RECOMMENDED SERVICE BULLETIN

RSB 40-047/4

RSB D4-052/4

WORK INSTRUCTION WI-RSB-D4-052 "REPLACEMENT OF RH AILERON AND GMU 44 RELOCATION"

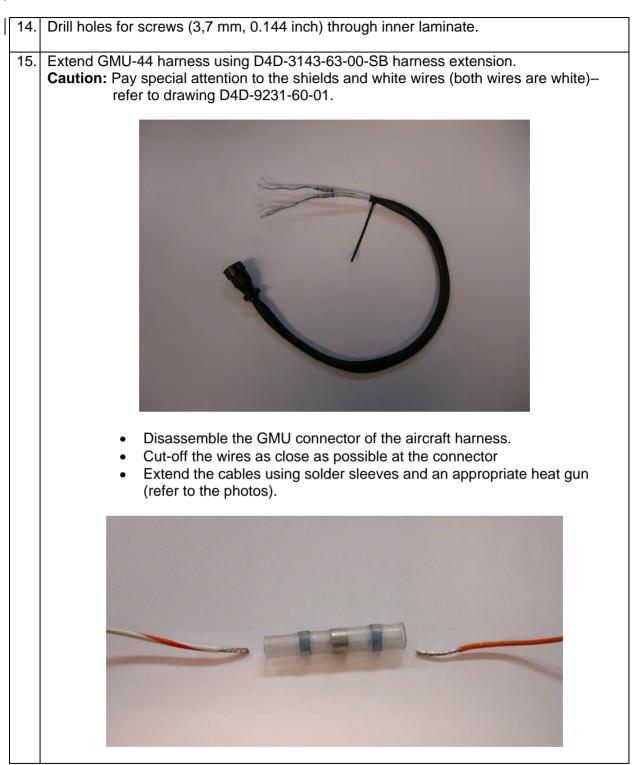
1.	If RSB D4-052, RSB D4-052/1 or RSB D4-052/2 has been complied with, proceed with item 8.
2.	Remove right hand aileron according to the instructions given in AMM Section 57-60.
3.	Install aileron p/n DA4-5762-00-00_1 according to the instructions given in AMM Chapter 57.
4.	Carry out aileron control system test procedure according to AMM Section 27-10.
5.	Carry out aileron adjustment procedures if out of tolerance.

6.	Remove the GMU 44 magnetometer in accordance with the instructions given in the AMM.
7.	Replace the 4 screws of the strain relief of the GMU 44 connector and harness connector with DIN 7971-C3.5x13-A2 screws.
8.	Remove RH wing-tip.
9.	Mark drillholes using marking template D4D-5741-00-SO. Refer to Drawing D4D-5741- 00-00x02 and photos. Note: Use notch on Template for measuring. Caution: You must not use marking template as a drilling template!
	345 mm inboard of this edge Or 375 mm inboard of trim edge

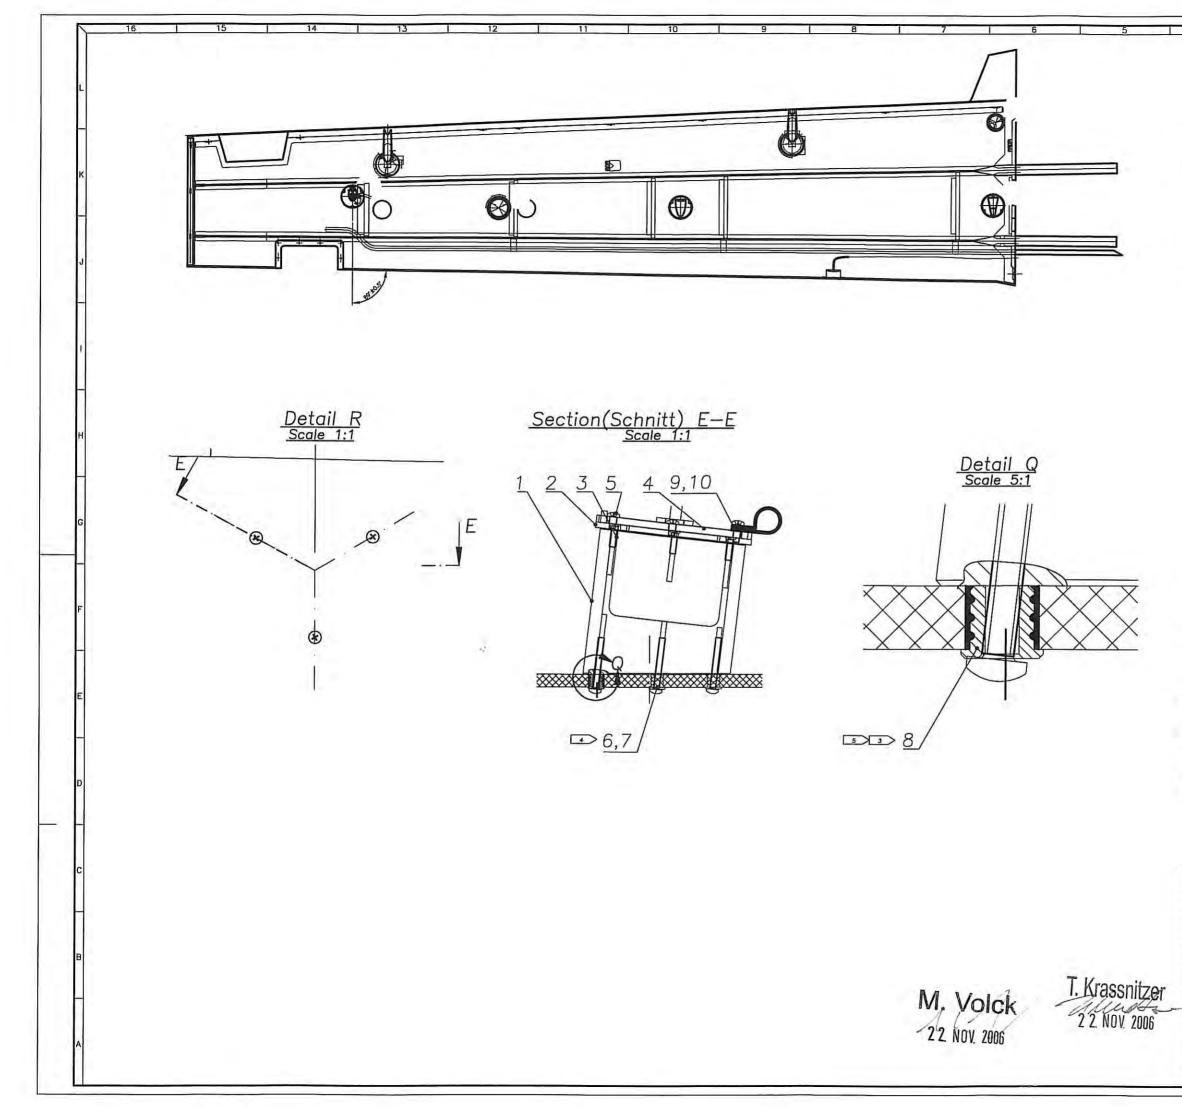
Diese Zeichnung ist nur gültig wenn im Detail R KEIN Wartungsausschnitt vorhanden ist. This drawing is only valid if there is no access hole in Detail R Image: Second S	
10 - 3 HS35214-25 Linsenschroube 9 - 1 187-7700 Schelle 8 - 3 D40-5741-00-30 Collar Bush 7 - 3 H535214-29 Linsenkopfechroube 6 - 3 DN 125X-044-PA Schelle	 Wartungsausschnitt vorhanden ist. This drawing is only valid if there is no access hole in Detail R Für das Markieren der Bohrungsposition ist die Schablone D4D-5741-00-S0 zu verwenden. To mark the drillhole position use template D4D-5741-00-S0 Inneres Laminat der Sandwich-Konstruktion stehen lassen nur Loch für Schraube bohren keep inner laminate of sandwich-structure drill only hole for screw Mit Loctite 262 sichern Secure with Loctite 262 Buchse mit Terostat MS 9380 Bond in bushing with Terostat MS 9380
5 - 2 MS35214-23 Unsenkopfachraube	10 - 3 MS35214-25 Unsenschroubs 9 - 1 187-7700 Schelle 8 - 3 D40-5741-00-30 Collor Bush 7 - 3 MS35214-29 Unsenkopfachtraube 6 - 3 D535214-29 Unsenkopfachtraube 6 - 3 DN1125A-M4-PA Schelbe
